**PLANNING COMMISSION  
MEETING AGENDA  
REGULAR MEETING**

**October 14, 2014**

SUBJECT: PRELIMINARY SITE PLAN REVIEW (File Number SP 1000) – Proposed Penske Automotive Group Parking Lot Expansion, North side of Maple, West of Stephenson (1225 East Maple), Section 26, Currently Zoned IB (Integrated Industrial and Business) District

## Preliminary Site Plan Review For City of Troy, Michigan

SHEET  
Landscape Plan

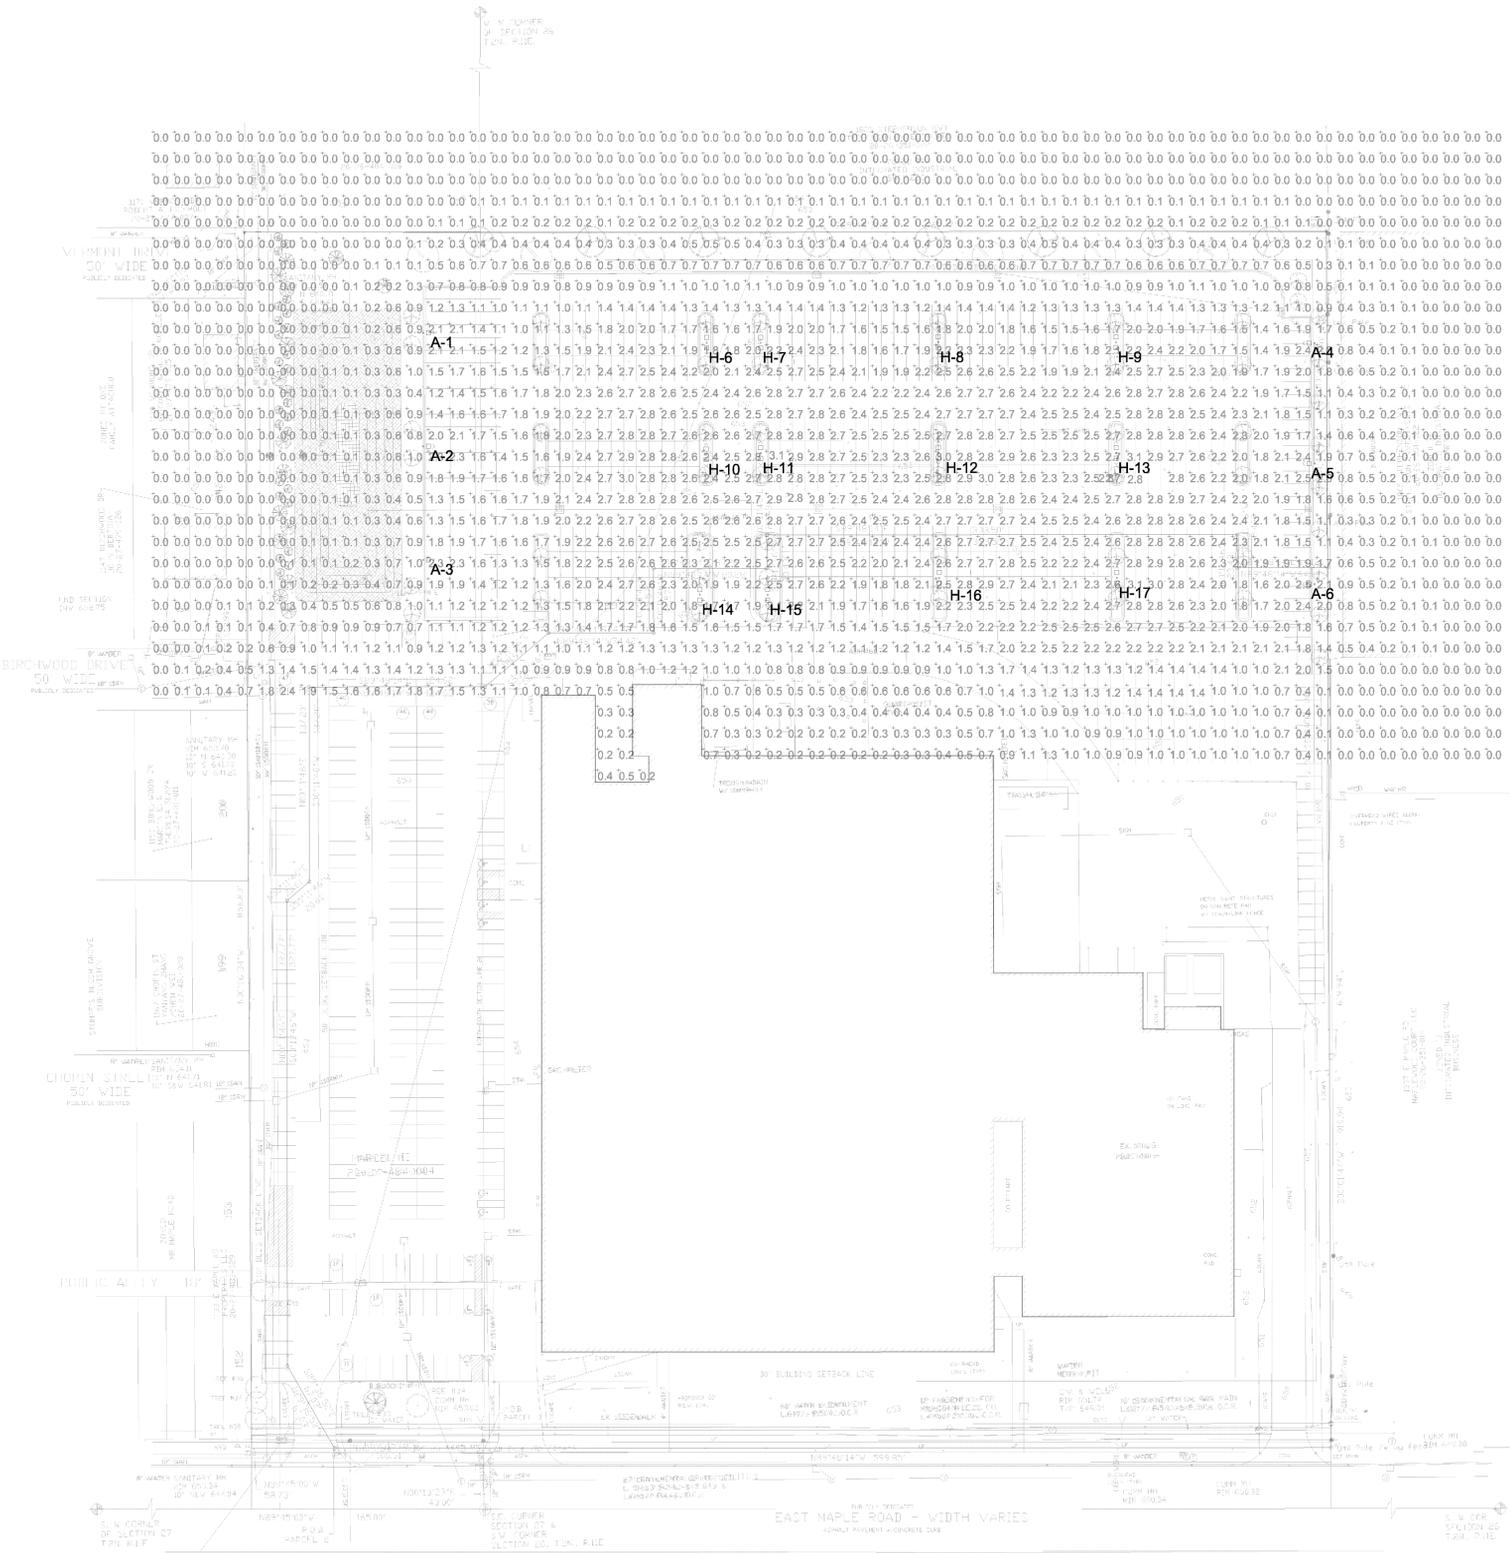
The applicant has provided a landscape plan.

Required	Provided	Compliance
<u>Parking Lot Landscaping:</u> 1 tree for every 8 parking spaces. Trees may be located adjacent to parking lot with planning commission approval.	566 spaces / 8 spaces per tree = 71 trees	38 trees in parking lot and 33 along perimeter.	The total number complies, but the location along the perimeter requires Planning Commission approval
<u>General Site Landscaping:</u> 20% of site area shall be landscaped	213,755 sq ft x 20% = 42,751 sq ft  (Calculation is based on a total project site of 6.6 acres)	47,044 sq ft = 22%	Complies
<u>Screening:</u> Opaque fence, wall, or 1 large evergreen per 10 lineal feet or 1 narrow evergreen per 5 lineal feet.	Opaque fence, wall, or 1 large evergreen per 10 lineal feet or 1 narrow evergreen per 5 lineal feet along western property line.	There is an existing tree buffer along the western property line.	Complies with conditions.

The applicant is showing a tree buffer along the detention pond; however it appears that the buffer is inside the proposed chain link fence. The applicant should provide a tree buffer of 1 large evergreen per 10 lineal feet, or 1 narrow evergreen per 5 lineal feet on the outside of the detention pond fence.

**Items to be Addressed:** 1). *Provide a tree buffer of 1 large evergreen per 10 lineal feet, or 1 narrow evergreen per 5 lineal feet on the outside of the detention pond fence; and 2). Supplement the landscape buffer along the western property line with additional trees where there are existing gaps.*

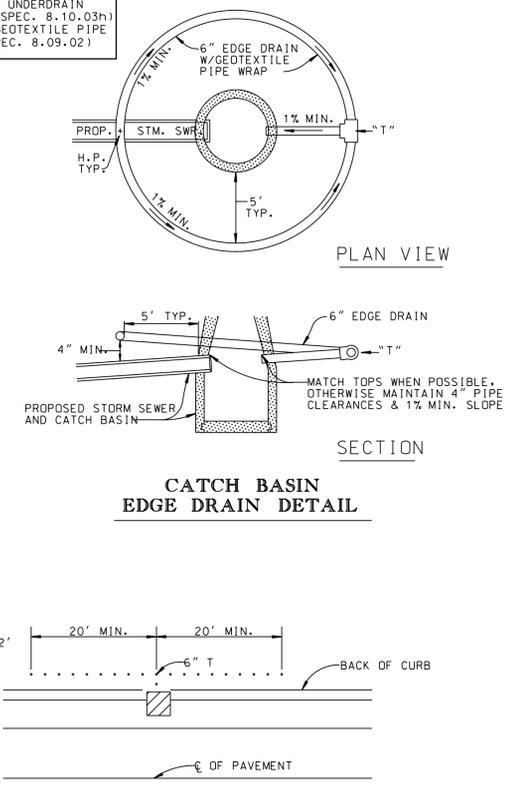
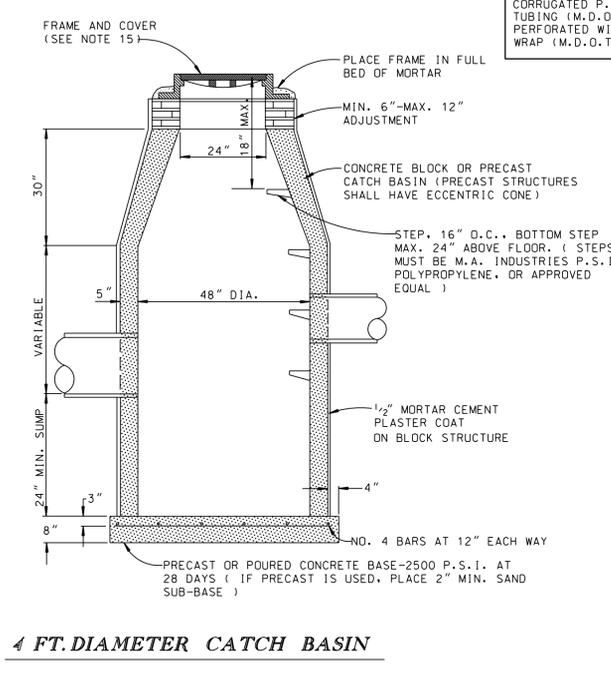
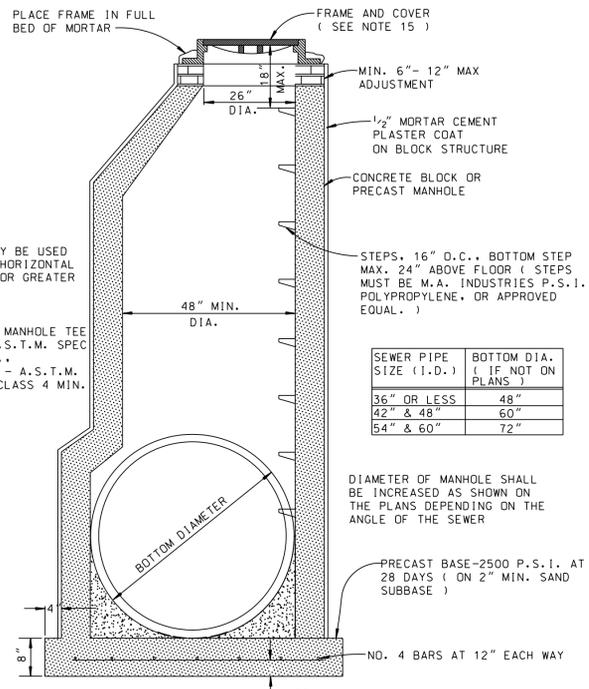
A Photometric Plan and lighting details have been provided. The applicant proposes eighteen (18) two-headed pole mounted lights. Due to the adjacent residential, the pole height cannot exceed 25-feet. The applicant shall confirm the lighting pole height. In addition, the applicant shall confirm that the fixtures are fully shielded or full cut off. The photometric reading slightly exceeds the allowable light level at along the western (adjacent to residential) property line and the eastern property line.

**Items to be Addressed:** 1). Confirm that pole height does not exceed 25-feet; 2). Provide lighting cut sheets to confirm that the fixtures are fully shielded or full cut off; and 3). Reduce lighting along western and eastern property line.

**CONCEPTUAL SITE PLAN**  
 PROPOSED MULTI-FAMILY DEVELOPMENT  
 SHAFER DEVELOPMENT  
 TROY, MI

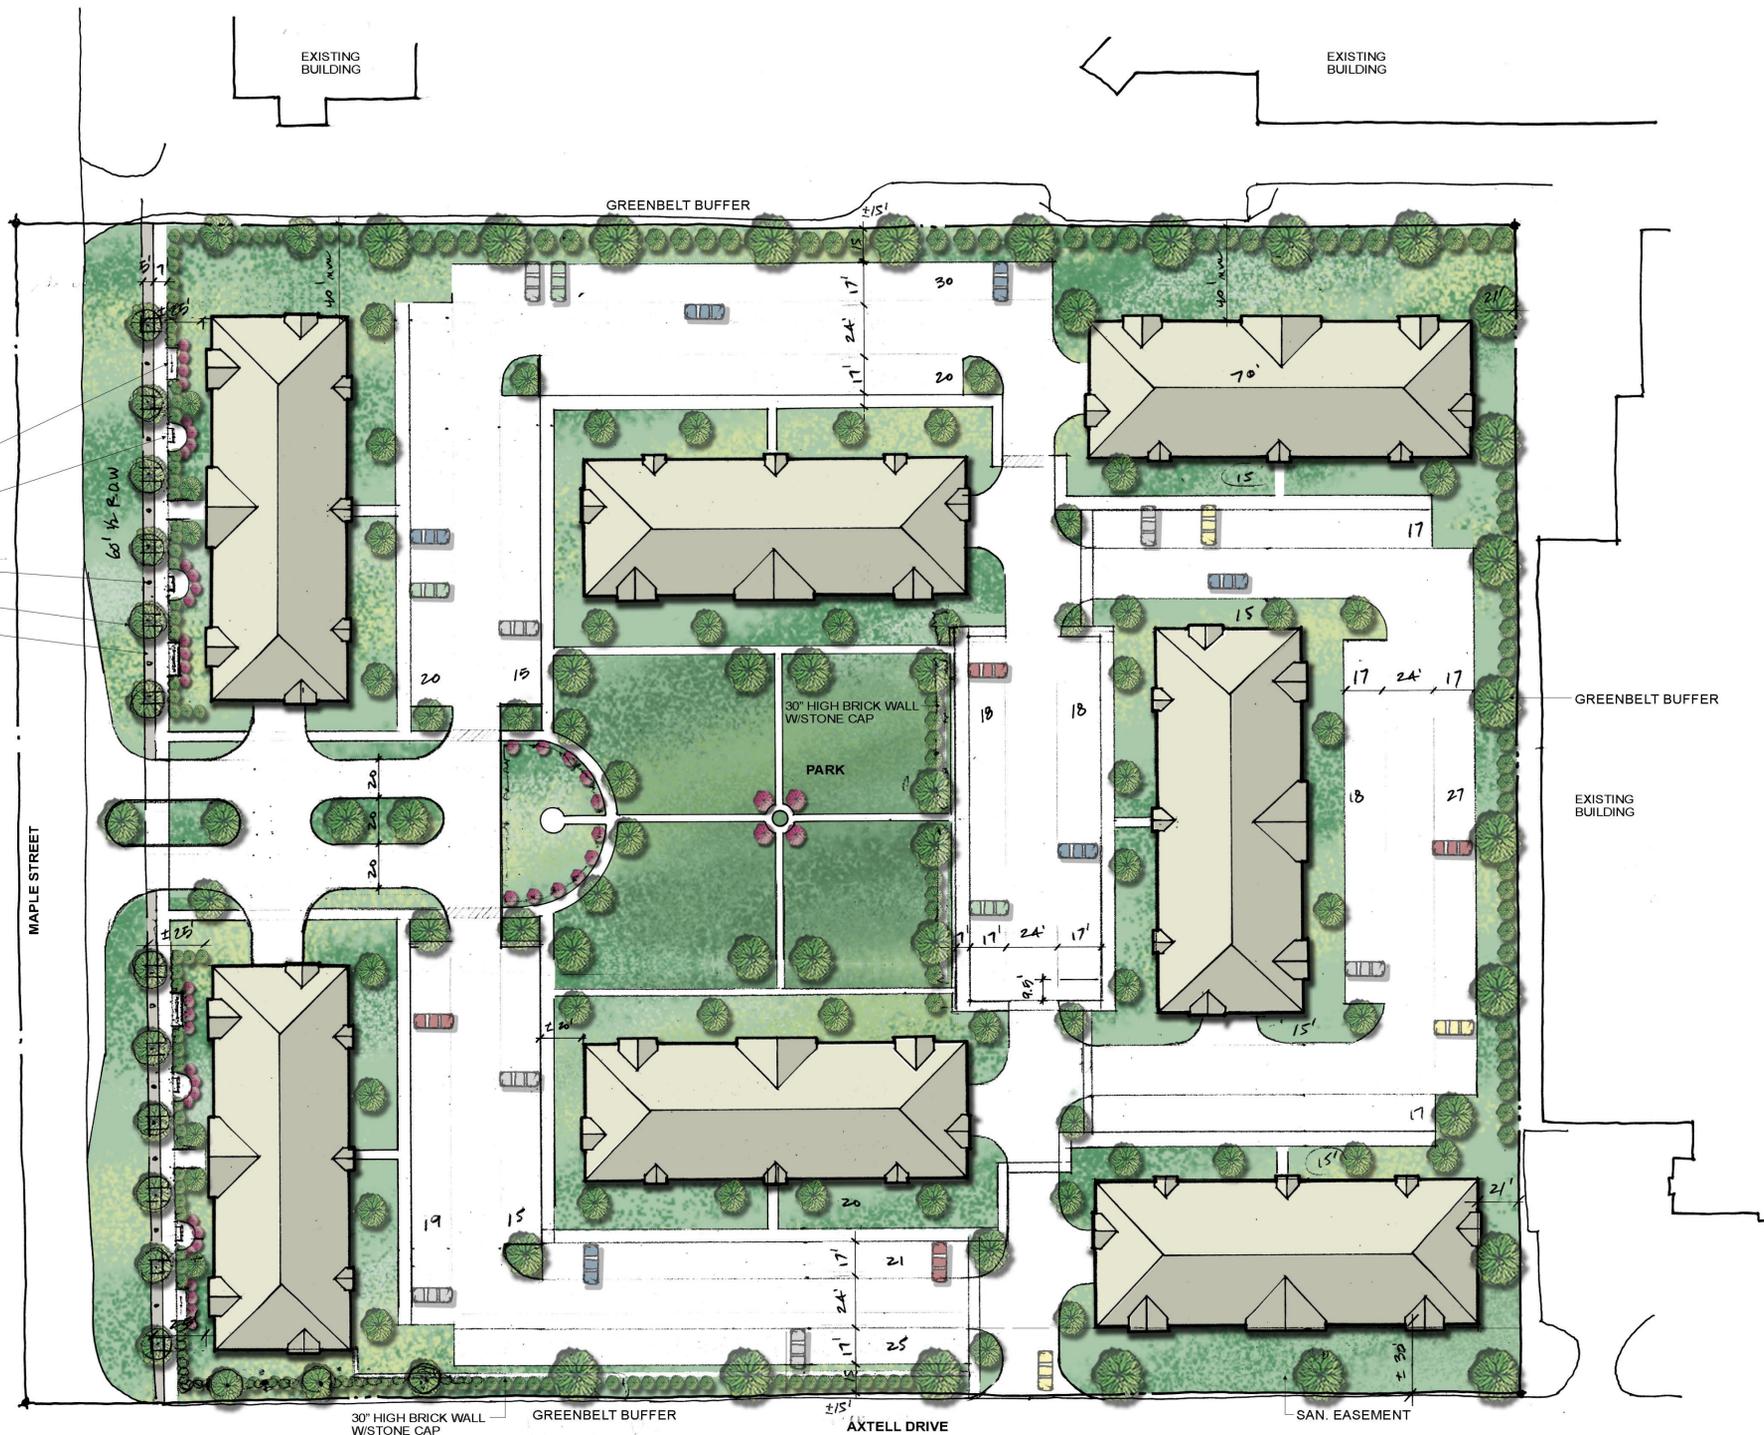
The applicant in making a significant investment in the site and has proposed attractive buildings. The submitted development meets many of the objectives of the 2008 plan and the draft 2014 plan. However, in continuing to push the evolution of Maple Road from an auto-dominated corridor to one that offers multiple transportation options and mixed use opportunities, we offer the following comments to be considered by the Planning Commission and applicant:

- 1) The size of the site is large enough to allow for creative site planning. The layout and site access with the boulevard drive-approach is very auto-oriented. One option to consider is to bisect the site with a main “urban” street and incorporate more of an interior street grid and alley pattern. Dividing the development with street(s) and alleys will eliminate the superblock and create a more walkable development. The urban style street grid would encourage the pedestrian and could allow for a mix of uses if desired by the applicant.

- 3) The applicant may need to slightly reduce the massing of the building in order to reorient the site plan. The applicant may be able to add additional smaller building(s) to offset reducing size of proposed ones.

- 5) The first floor of every unit is parking. Parking on the first floor creates a “dead” pedestrian space. While parking may be appropriate on the first floor for the interior buildings, alternative uses should be considered for the first floor of the buildings that front on Maple Road. The draft 2014 Maple Road Corridor Plan states that ground-level retail should be a focus of buildings in activity zones. We encourage the applicant to consider some retail or mixed use development along the first floor of buildings. The loss of residential units for those units on Maple Road may be made up elsewhere in the development.
